REMARKS

Application No. 10/800,396
Paper Dated: August 22, 2005
In Response to Office Action Dated: April 22, 2005
Attorney Docket No. 0388-043714

AMENDMENTS TO THE DRAWINGS

FIG.5

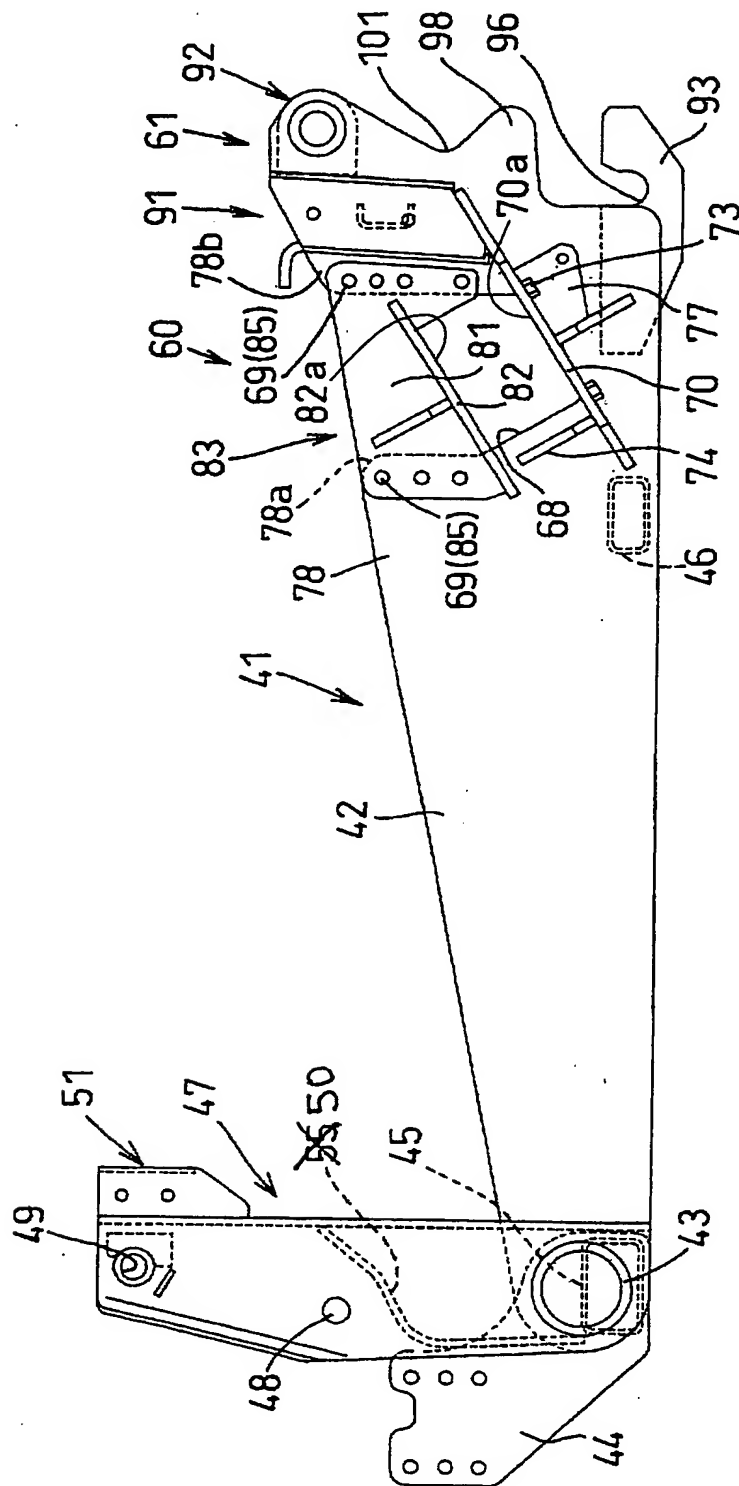
In the drawings, Fig. 5 has been amended to change previously labeled element 55 to element 50 in accordance with the remainder of the application such as, for example, Fig. 8. Fig. 14 in the drawings is further clarified by labeling the cutout opening sides 79 with lead lines as described in the written description at page 14, lines 28-30, for example.

In Fig. 5, previously labeled element 55 has been changed to element 50. In Fig. 14, the cutout opening sides (element 79) have been labeled.
